**ADDENDUM NO. 02  
TO THE CONSTRUCTION DOCUMENTS BID PACKAGE**

**Client:** Arrowhead Regional Medical Center  
**Project:** Oncology-Ambulatory Clinic  
**SHA Project No.:** 18242.100  
**Date:** September 12, 2019

A3 SECOND FLOOR DEMOLITION PLAN

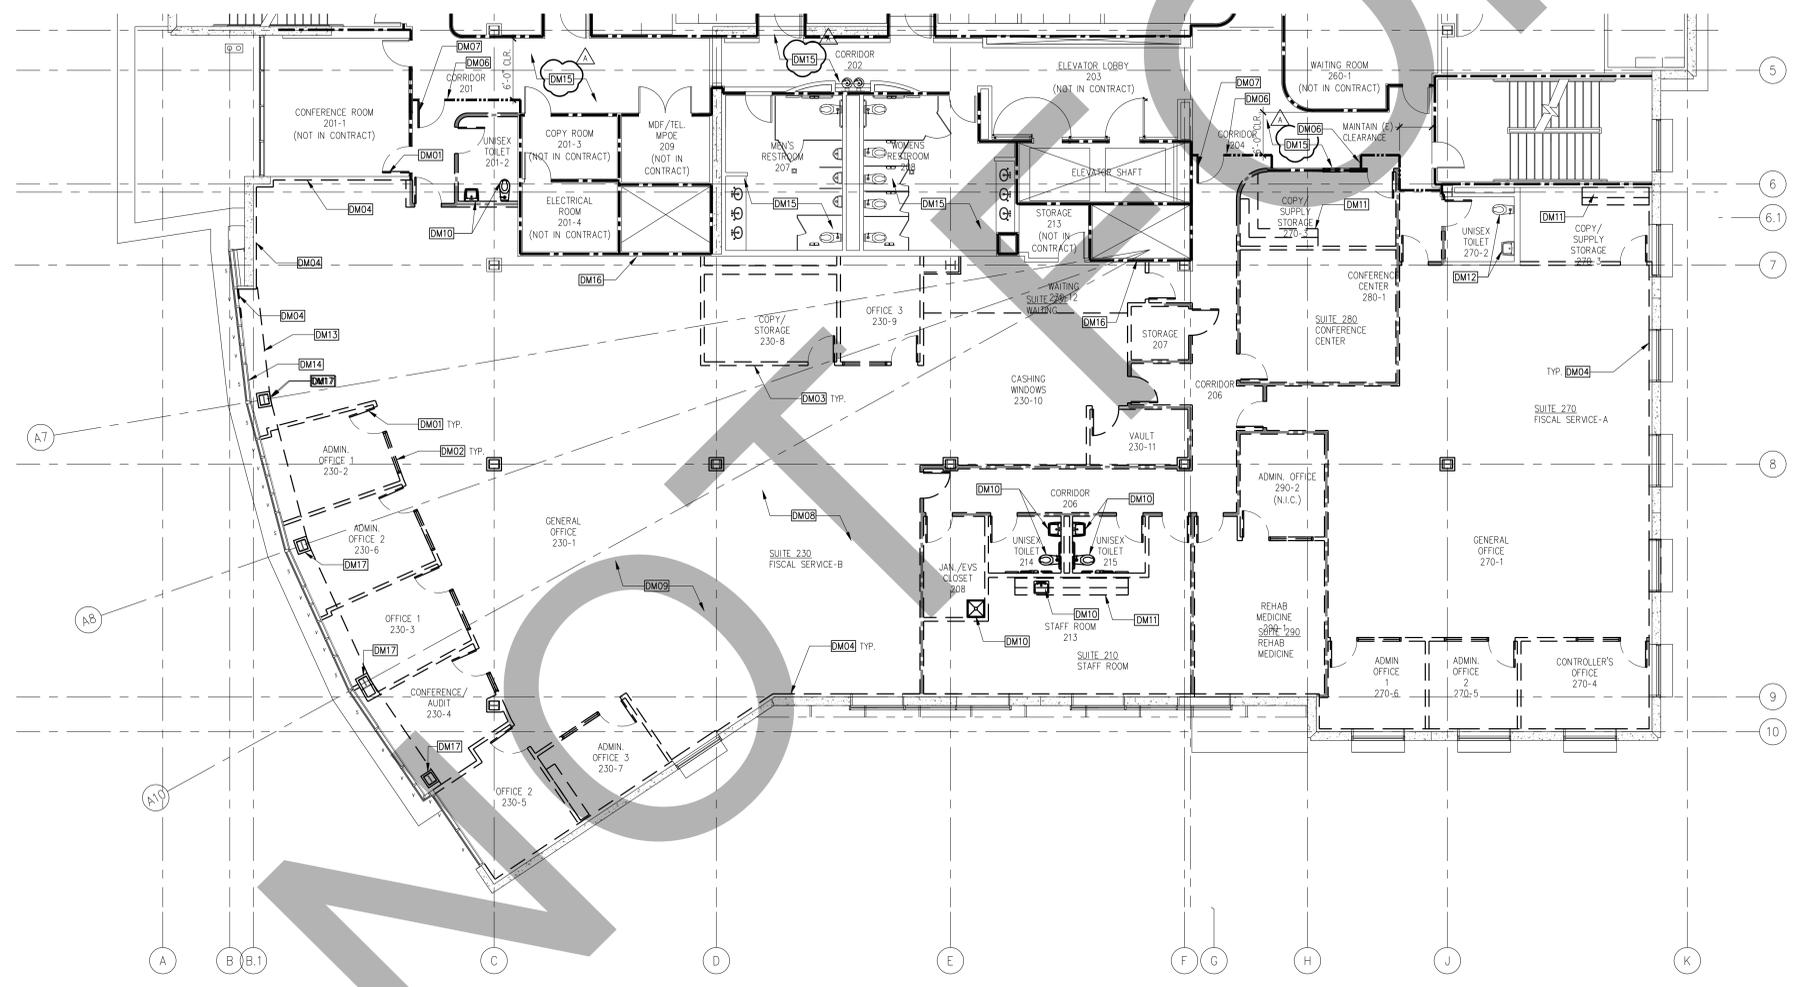
**A111** Existing room names added to the corridor that is to the north of the project area, scope revised to indicate partial demolition of the ceiling in this corridor.

002.5	Sheet A111 DM15 shows removal of ceiling in restrooms 207 & 208. Sheet M122 shows these areas as "not in contract". Please confirm these areas are in the scope of work.	Keynote DM15 indicates to DEMOLISH EXISTING CEILING AS REQUIRED BY NEW MECHANICAL WORK ONLY. Coordinate with scope shown on Mechanical drawings. M122 should NOT indicate "NOT IN SCOPE". See revised Mechanical sheets attached.

007.1	Keynote DM04 on sheet A111 Demolition Plan calls to "Demolish Existing Gypsum Board On One Side Only, Protect Framing In Place" along the West, South & East perimeter walls, but keynote FP06 on sheet A122 Floor Plan - Area A calls for "Existing Gypsum Board Furring to Remain, Protect in Place. Please advise if existing gypsum board along the perimeter wall is to remain, or to be demolished and replaced with new framing and drywall.	Existing gypsum board along all perimeter walls is to be demolished. FP06 on sheets A122 and A123 has been revised to indicated existing framing with new 5/8" gypsum wall board.

**A4** PARTIAL FLOOR PLAN - AREA 'A'

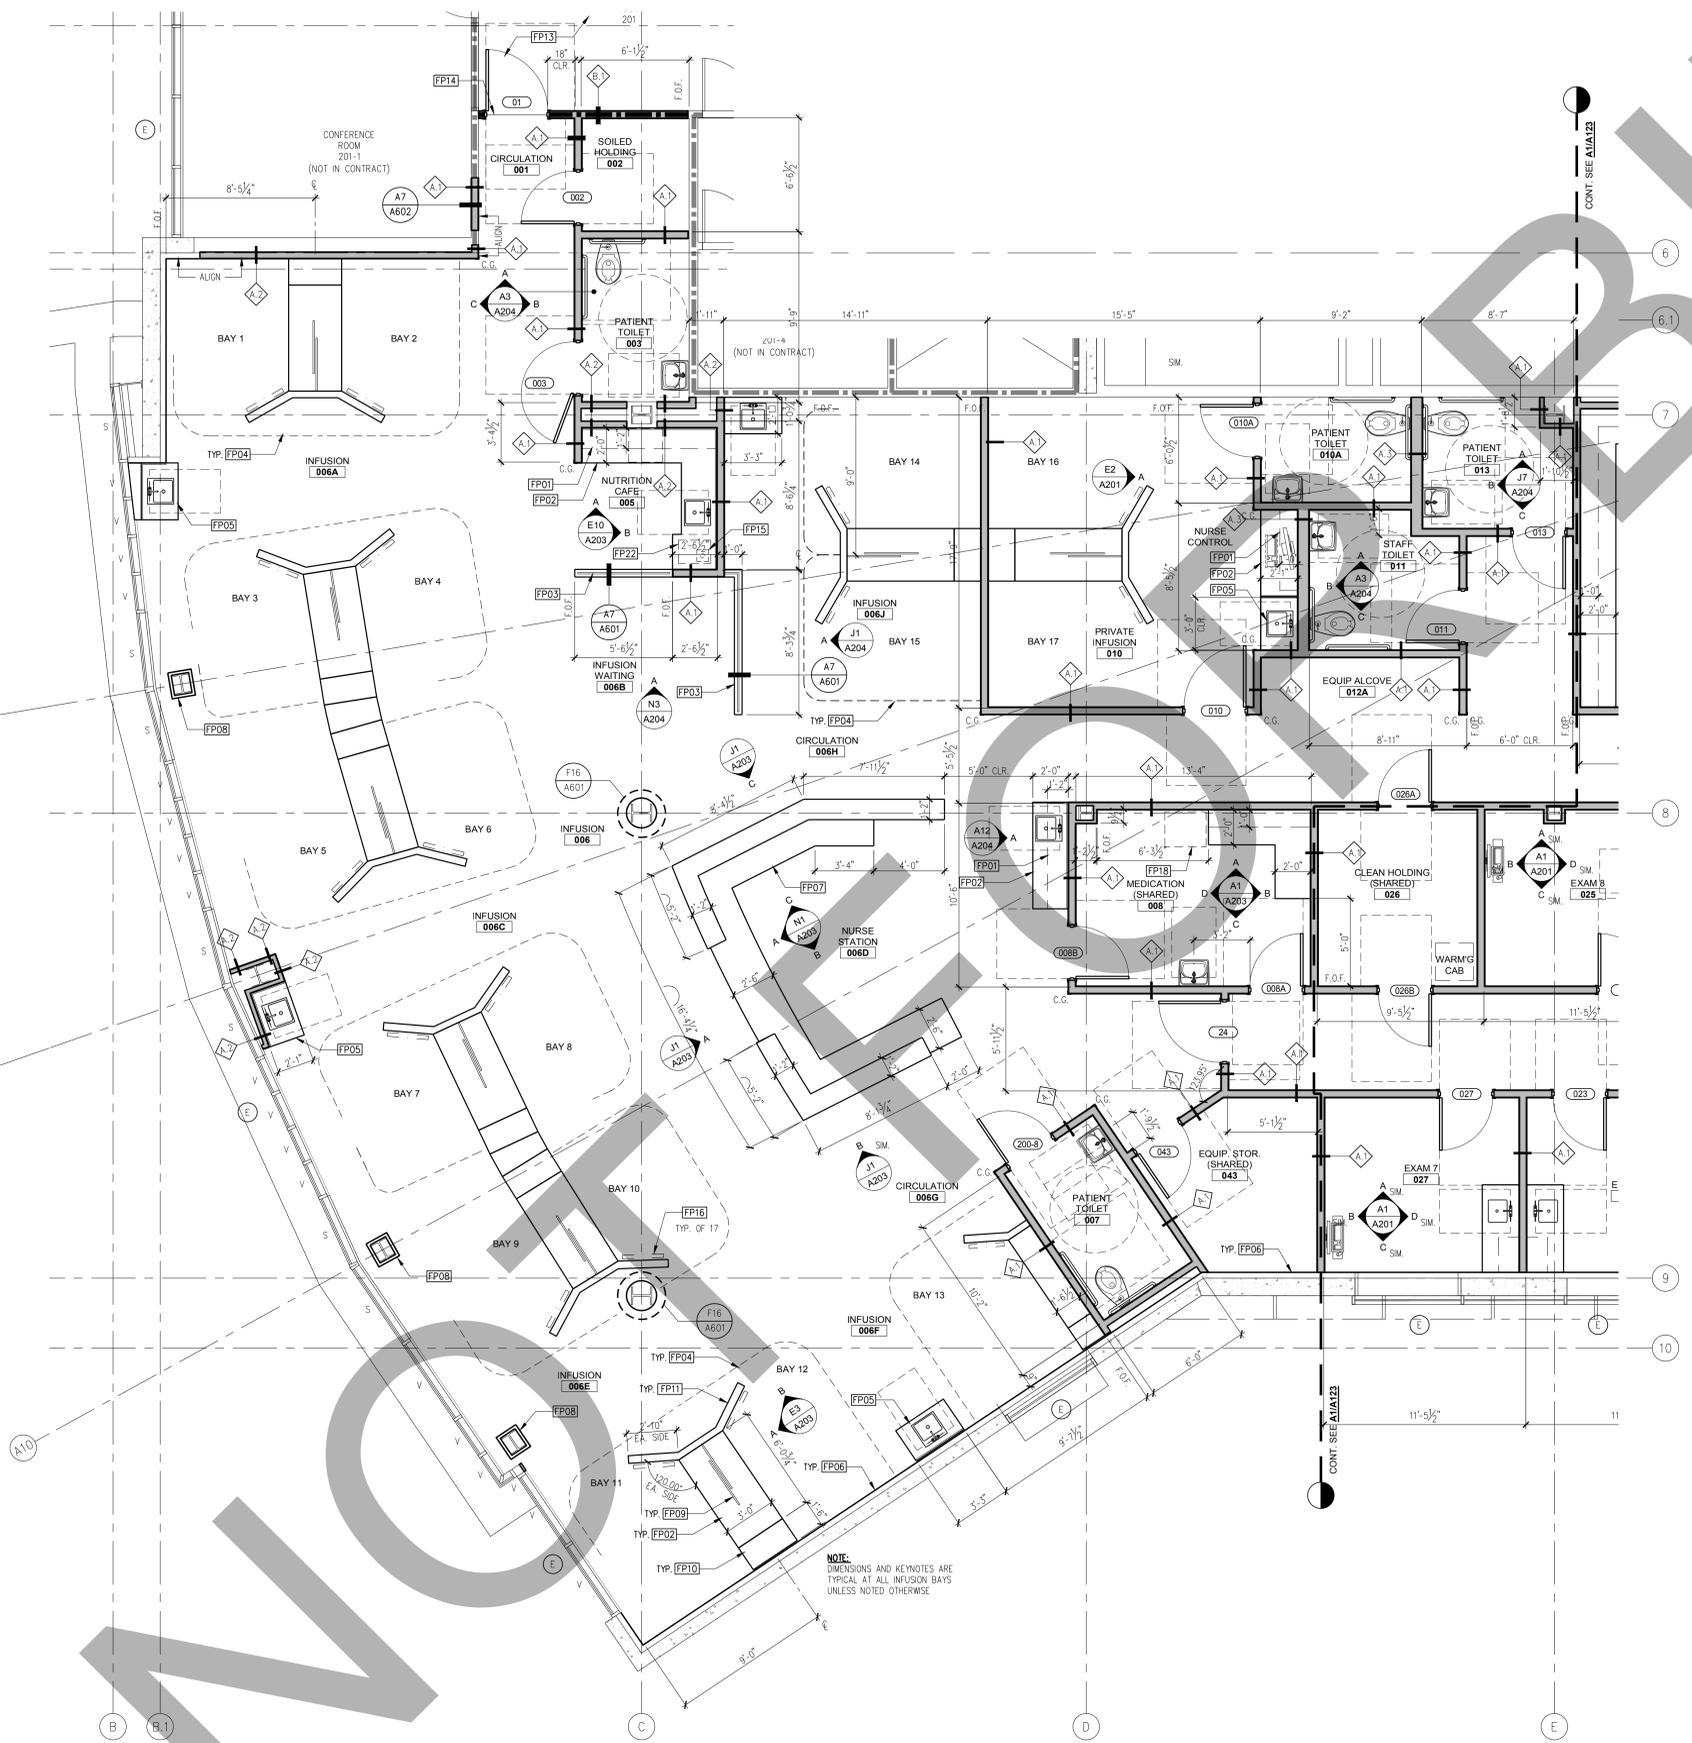
**A122** Keynote FP06 revised to indicate new gypsum board at existing framing.

**A3** SECOND FLOOR OVERALL REFLECTED CEILING PLAN

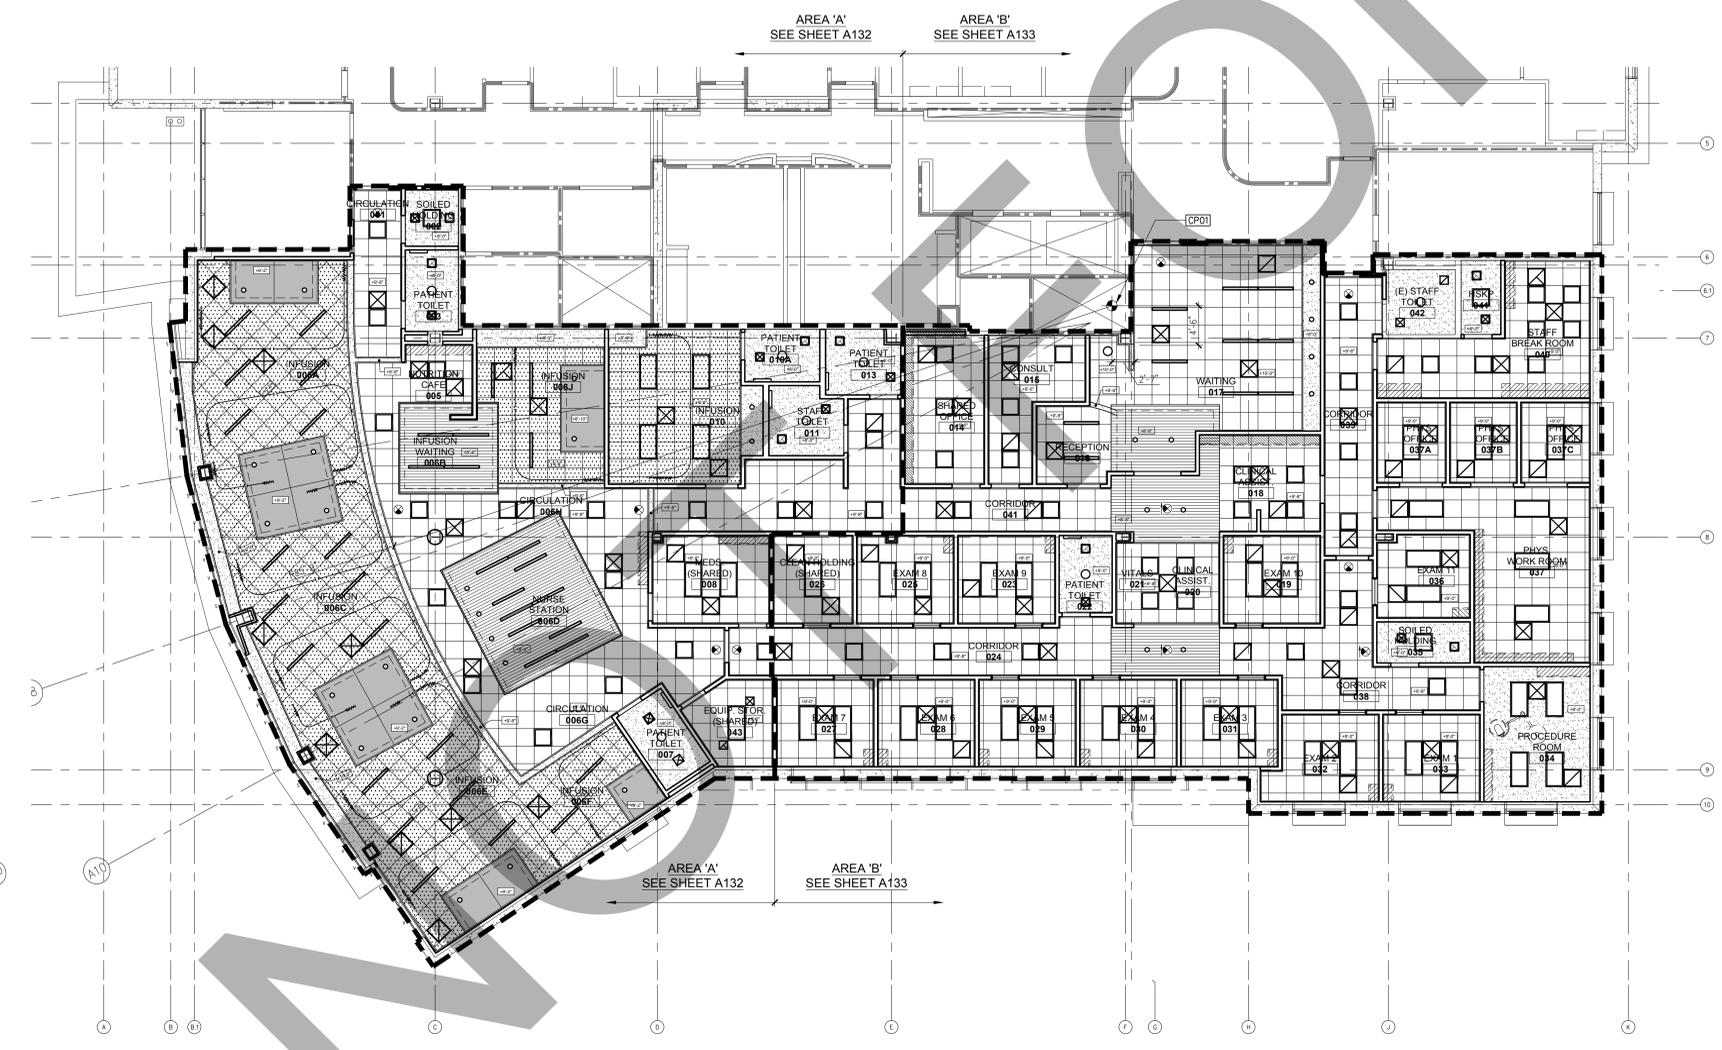
- A123** Keynote FP06 revised to indicate new gypsum board at existing framing.
- A131** General Note added to sheet regarding patching back of existing ceilings in corridor.  
General Note regarding Owner Furnished Items added to General Notes.

**N2 CLINICAL ASSISTANT 018** SCALE: 3/8"=1'-0"

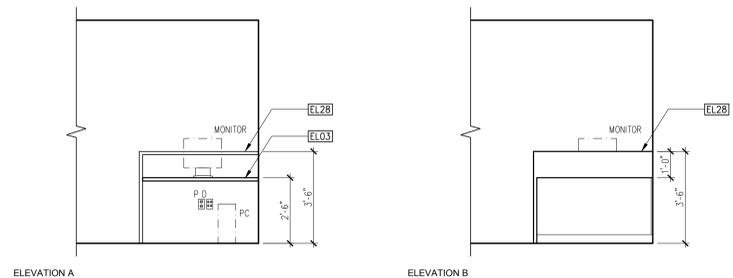
- A201** Clinical Assistant 018 Interior Elevation E added to sheet at N2/-.  
Cabinet locks added to various elevations and Keynote EL30 added to Keynotes.  
General Note prohibiting cabinet locks at accessible sink aprons added to General Notes.  
Detail callout revised to reference correct detail.

**A3** HVAC DEMOLITION PLAN

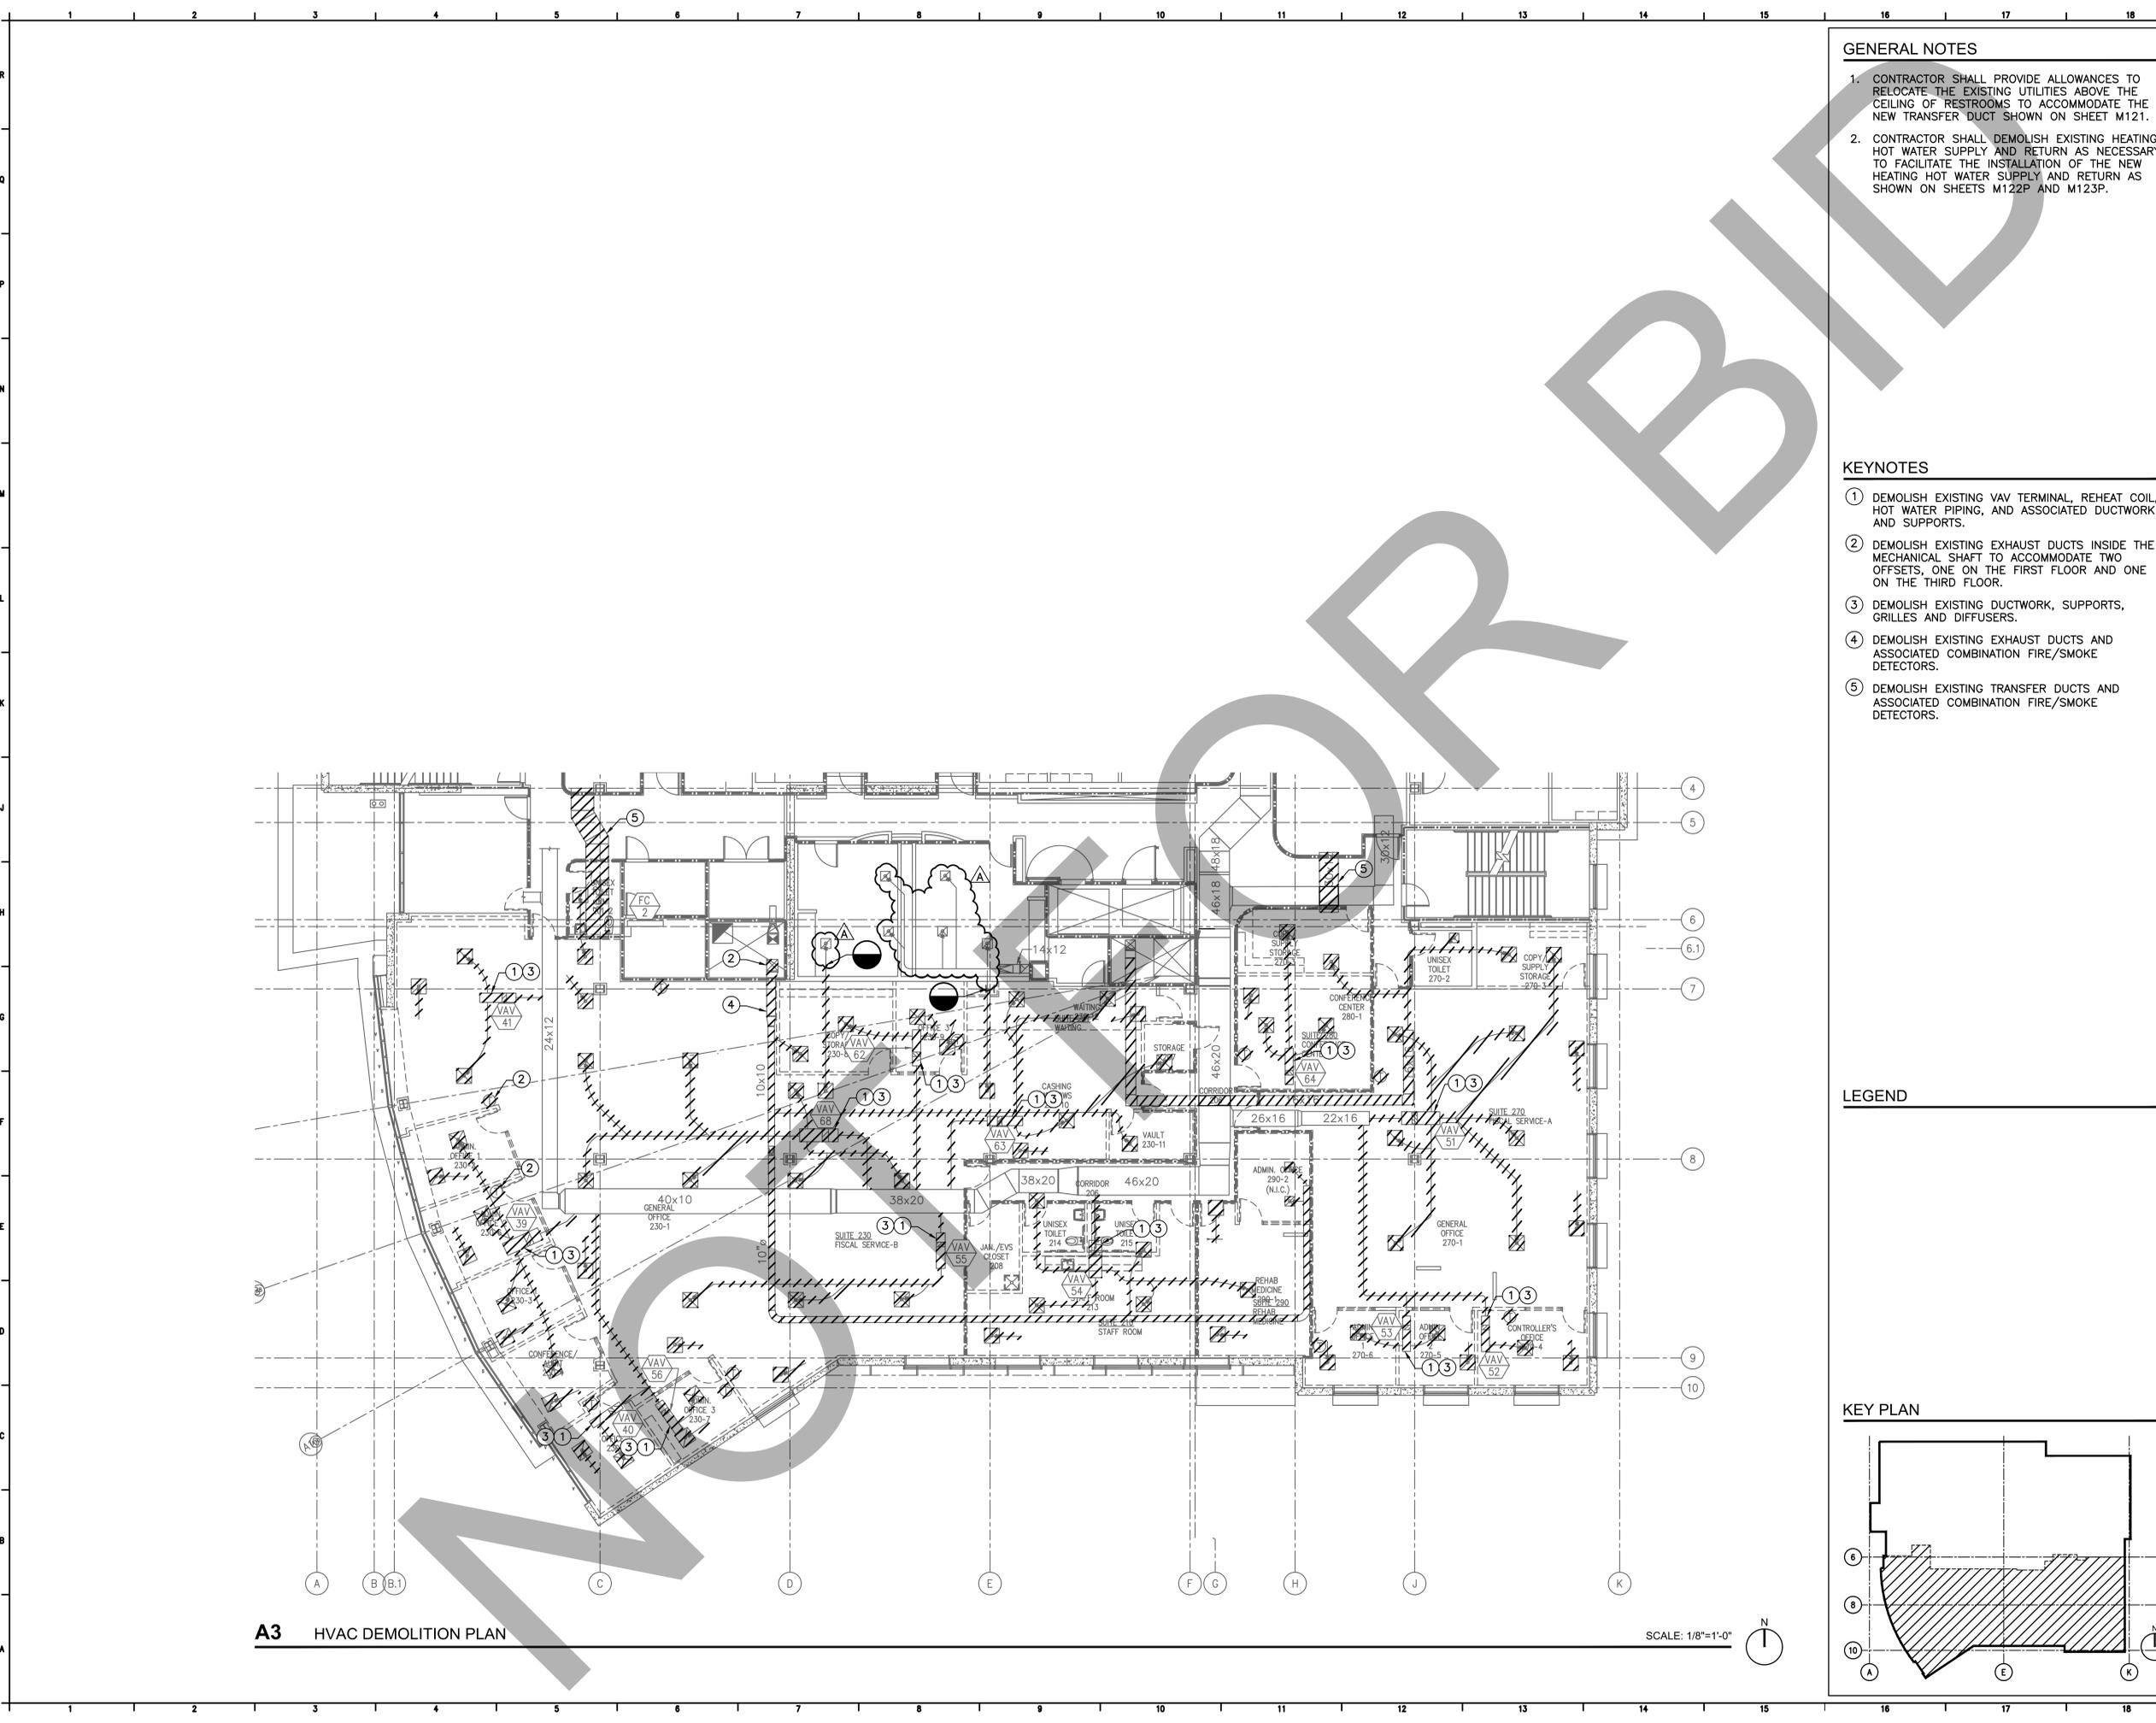
- A605** Revised detail number.
- M111** Revised demolition scope in the existing public restrooms.
- M122** Revised ductwork.
- M125** Added note to sheet regarding patching exterior finishes.  
Added General Note #4 referencing framing details.
